BTA Oil Producers
9418 Vaca Draw #1
Program to Reconfigure Wellbore
Johnson Ranch Field
Lea County, New Mexico

**Vaca Draw 9418 1
30-025-33639
BTA Oil Producers
April 22, 2014
Conditions of Approval**

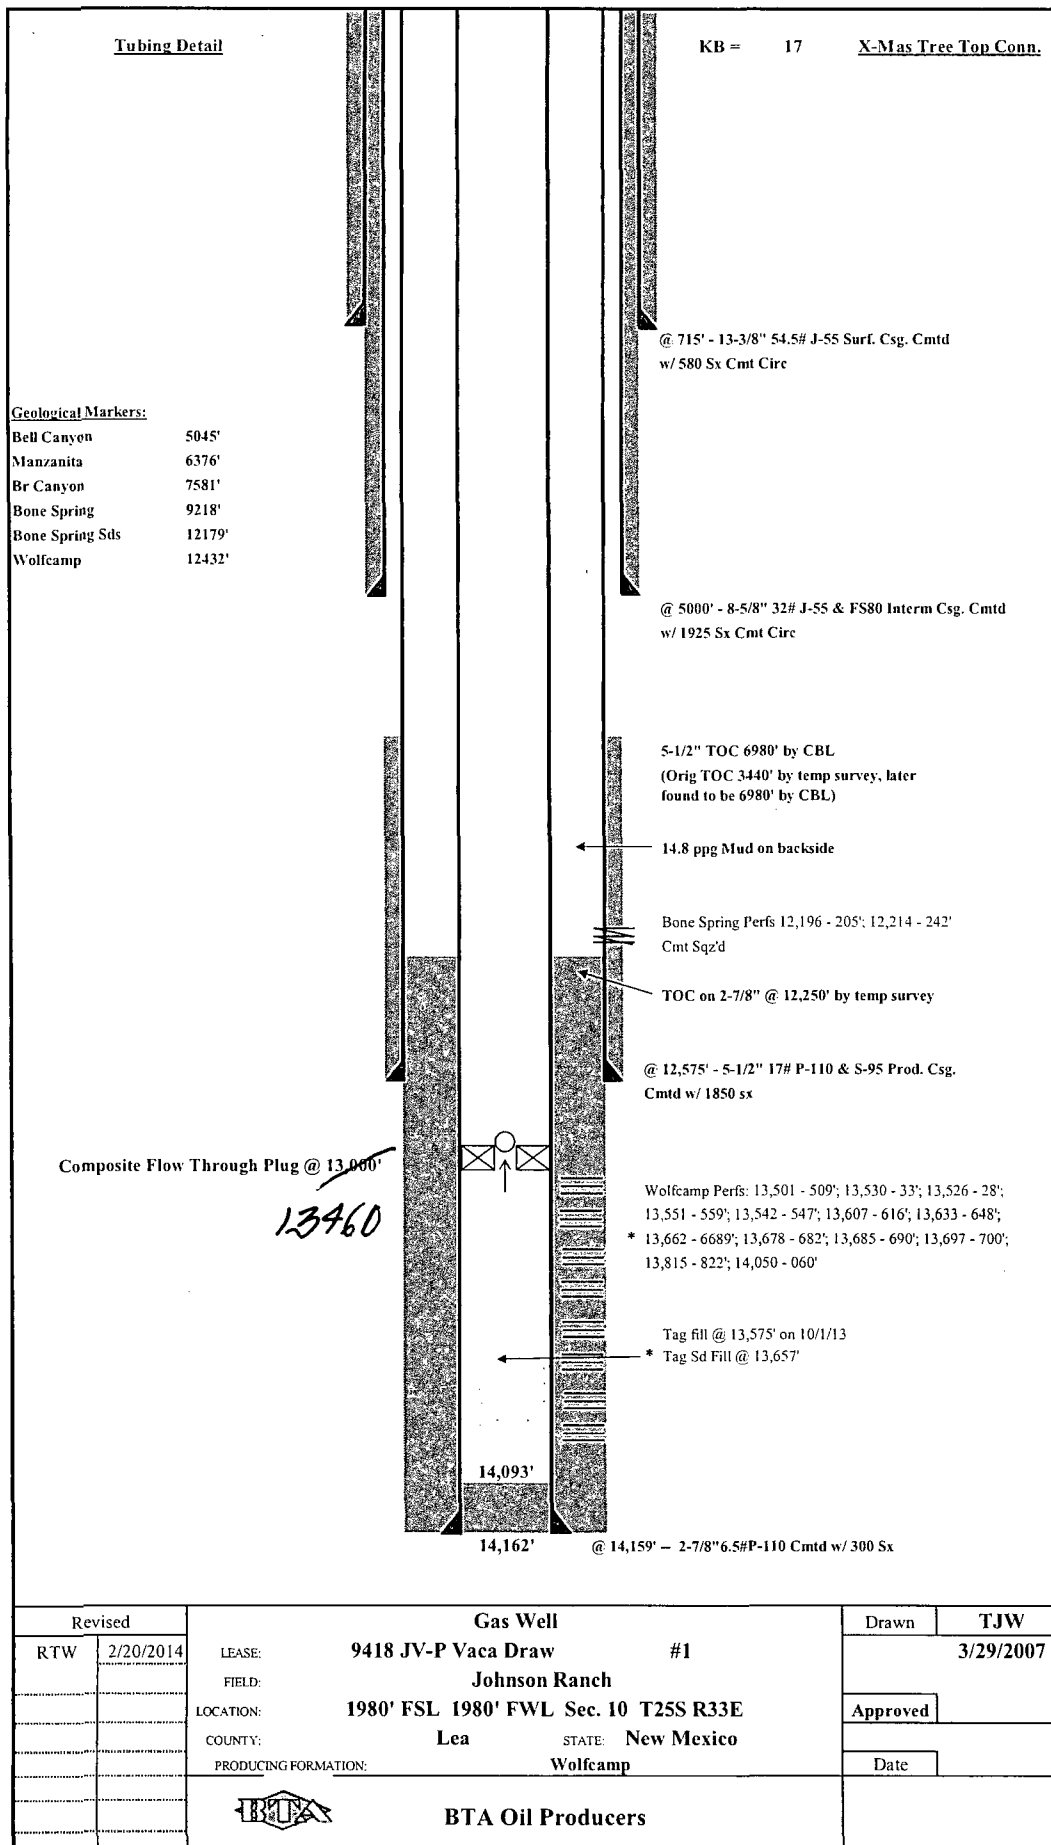
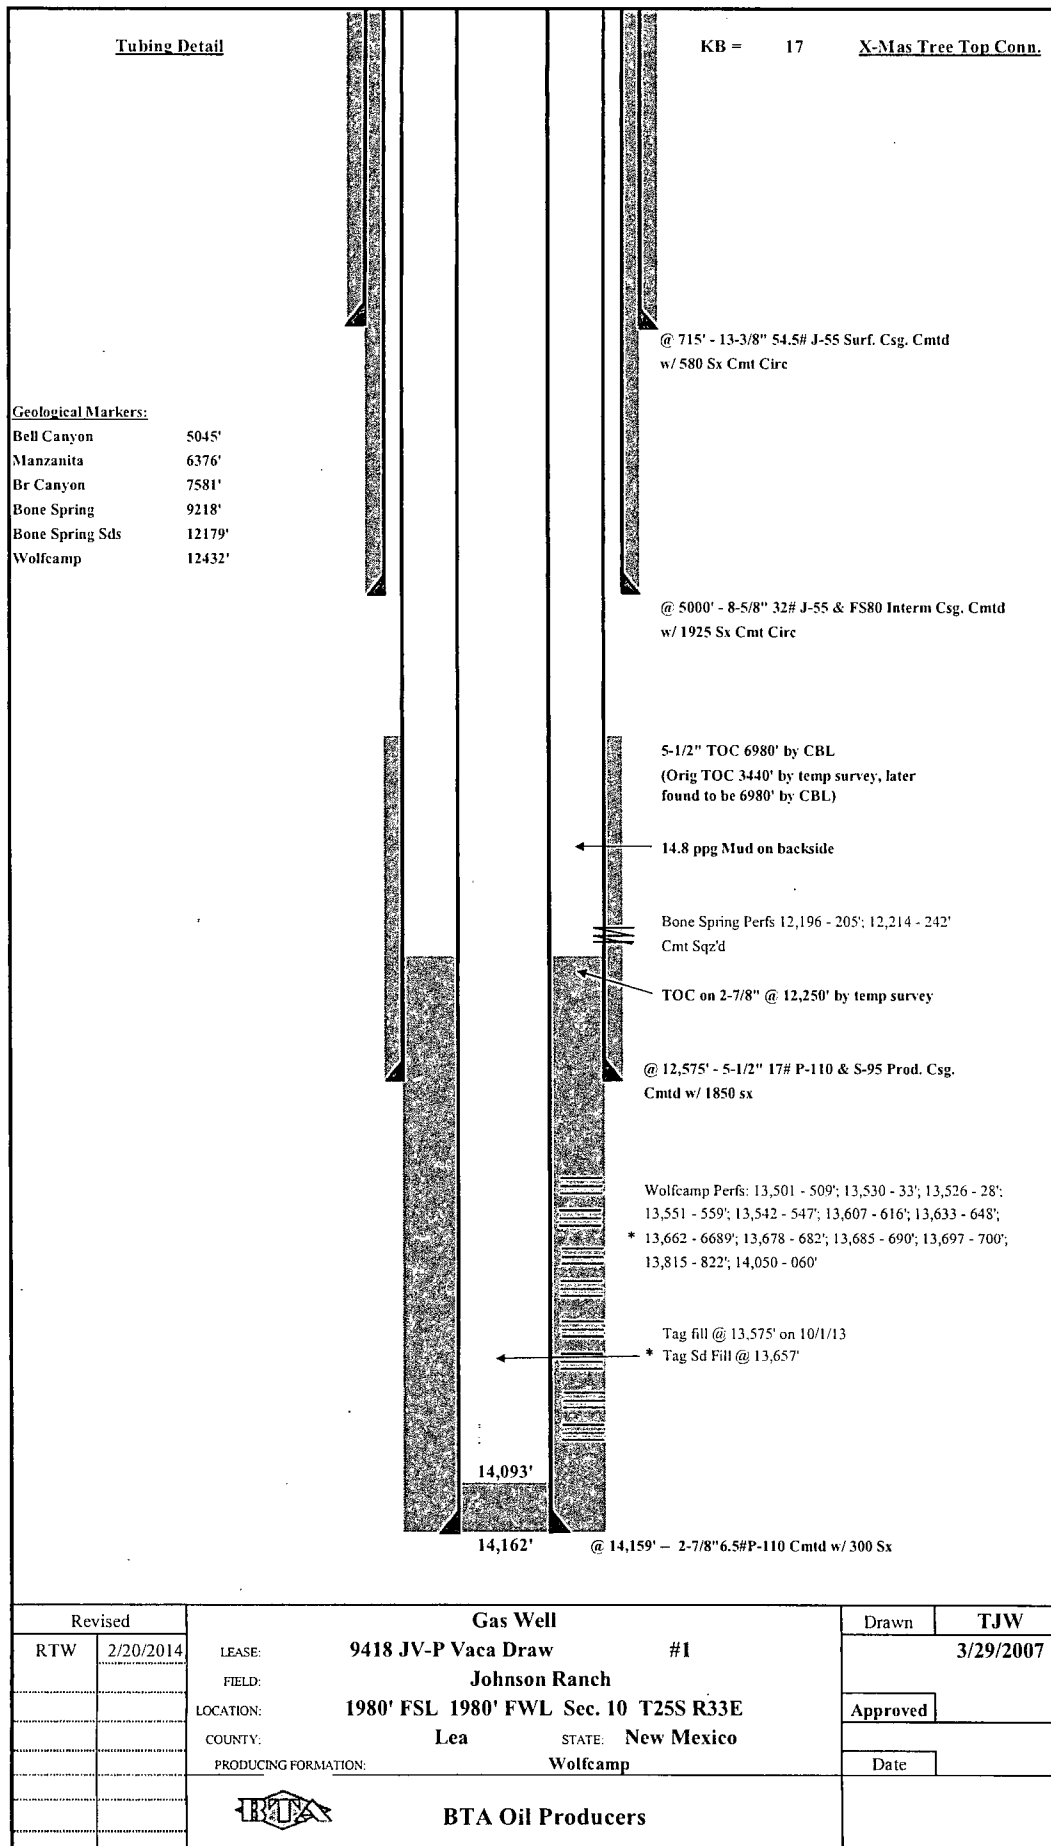
- 2. Schematic shows the flow through plug at 13,000' and the procedure at 13,460'. Operator shall set plug at 13,460'.**
- 3. Step 12 – submit an electronic copy of the CBL to the BLM.**
